**VILLAGE OF WESTMONT
PLANNING AND ZONING COMMISSION
AGENDA ITEM**

P/Z 16-024

TITLE: Wolf Pack Development, Inc. regarding the properties located at 1801 Midwest Road (Mayslake Village), Oak Brook, IL 60523 for the following:

RE: Proposed Mayslake Village Parking Improvement Project
1801 35th Street
Preliminary Review #1

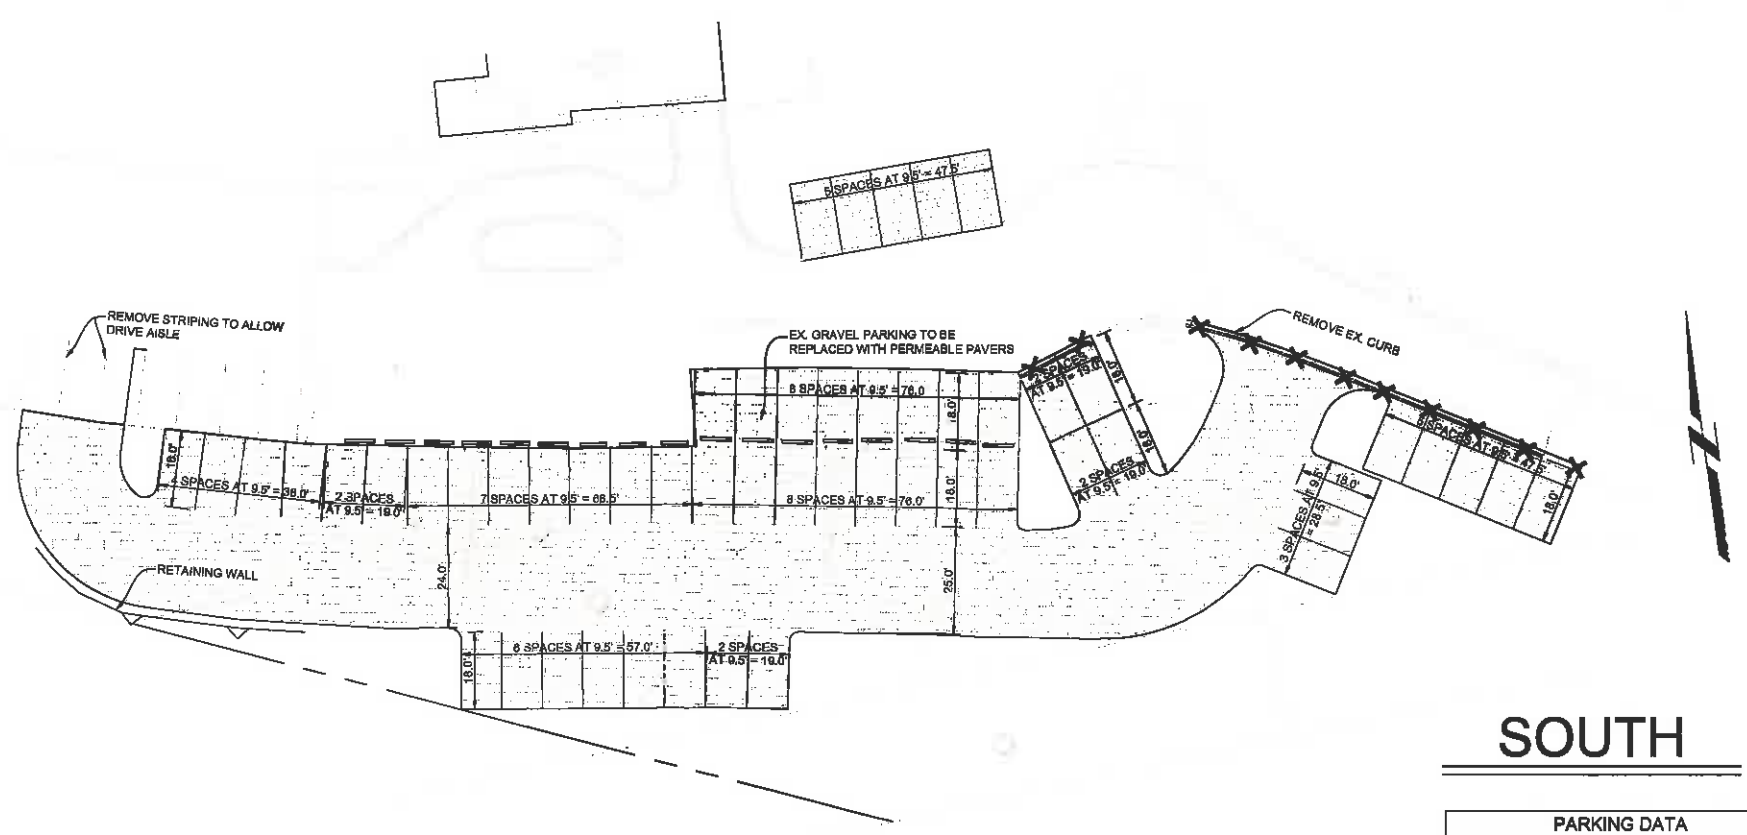
Underdrain and level spreader shown on the south area appears to be draining uphill. Please clarify.

Provide elevation information for the proposed berm shown with in the South area.

The level spreader has been (will be) adjusted on the final plans.

Elevation information has been added.

UTILITY & GRADING PLAN - WEST & SOUTH
MAYSLAKE VILLAGE PARKING IMPROVEMENTS
VILLAGE OF WESTMONT, ILLINOIS

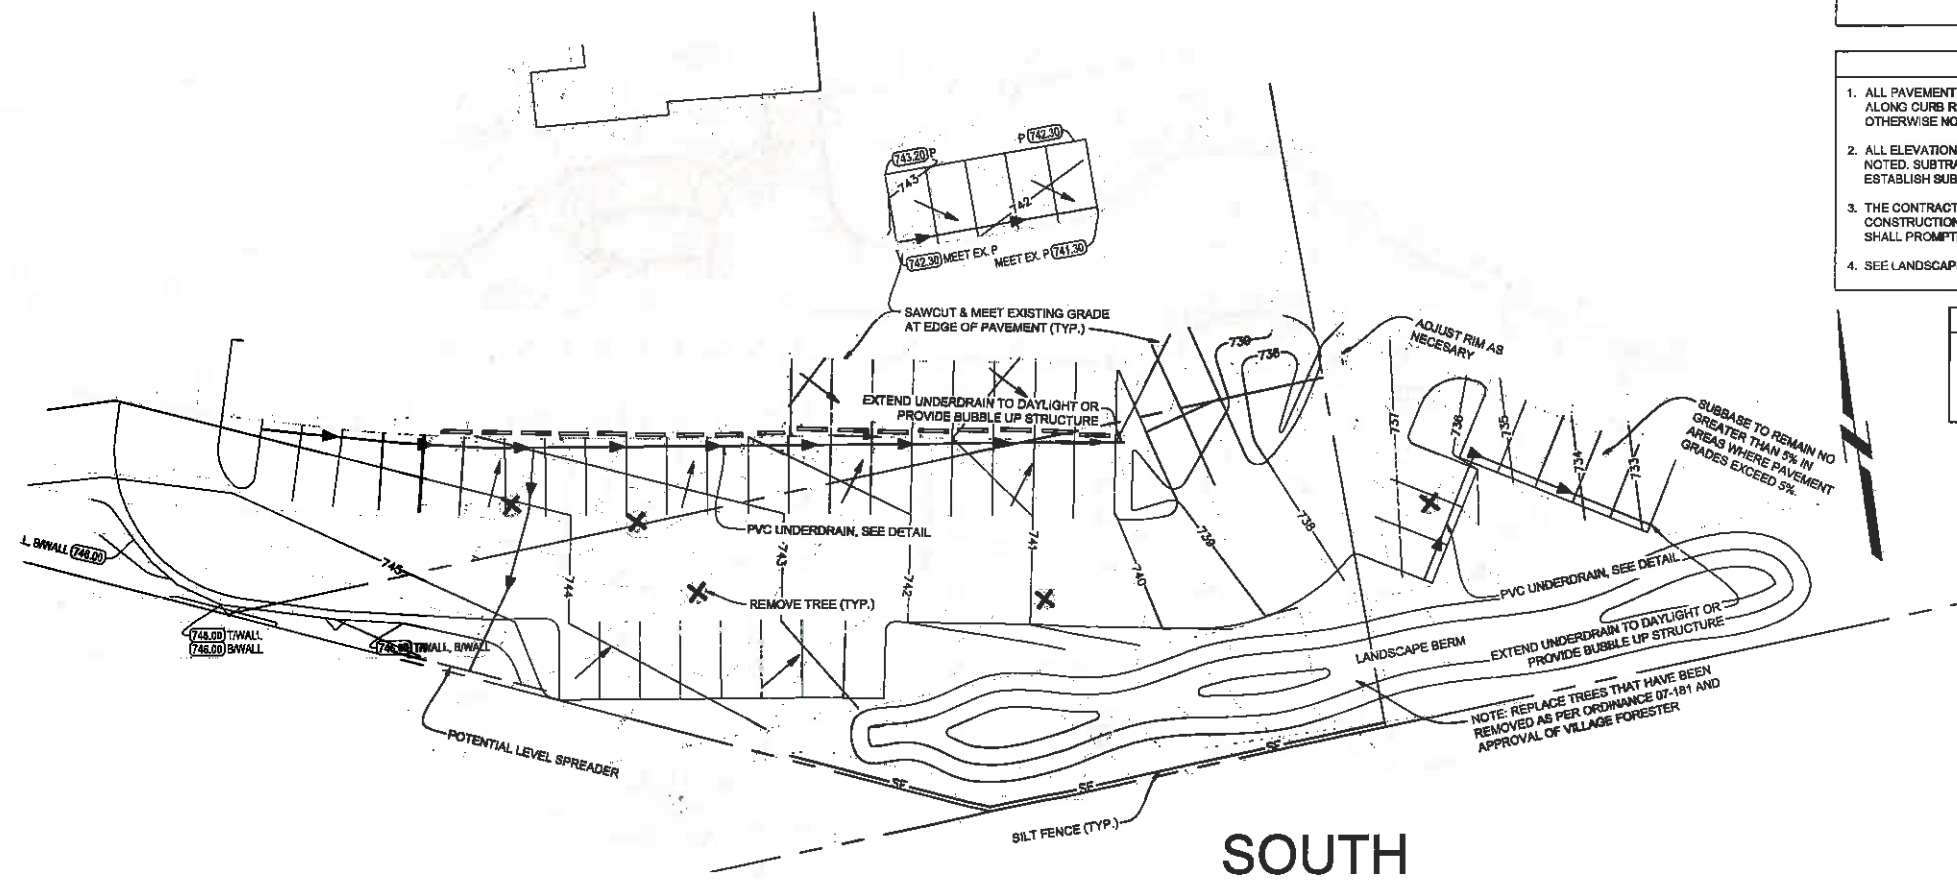
In the west area the gas line location and depth should be determined during the design phase so that if relocation is necessary, it can be completed prior to construction.

Provide grading information for the landscape buffer shown in the west area.

The west area is adjacent to a wetland/pond area and possibly encroaches on the wetland buffer. Coordination with the County is required. A double row of silt fence, at a minimum, is required.

If relocation of the main is required the spaces will most likely not be constructed. JULIE was contacted in design phase to locate the main but nothing has been marked in the area.

Additional grading has been provided.

A double row of silt fence has been added in the area adjacent to proposed parking at the west..

MAYSLAKE VILLAGE PARKING IMPROVEMENTS				
VILLAGE OF OAK BROOK, ILLINOIS				
AUTOTURN EXHIBIT				
DRAWN BY:	DATE:	SCALE:	PROJ. MGR.:	PROJECT #:
KM	11/03/2106	1"=40'	PJW

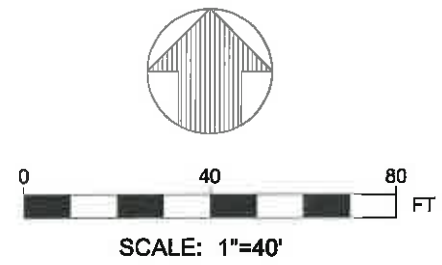
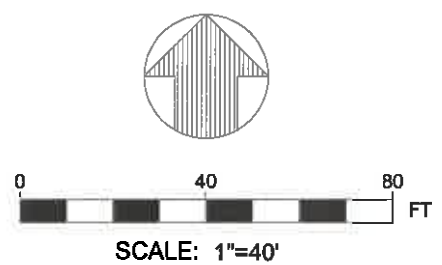
Provide auto-turn exhibits for relevant vehicle movements.

An auto-turn exhibit has been provided. The owner is not anticipating truck traffic in any of the proposed spaces.
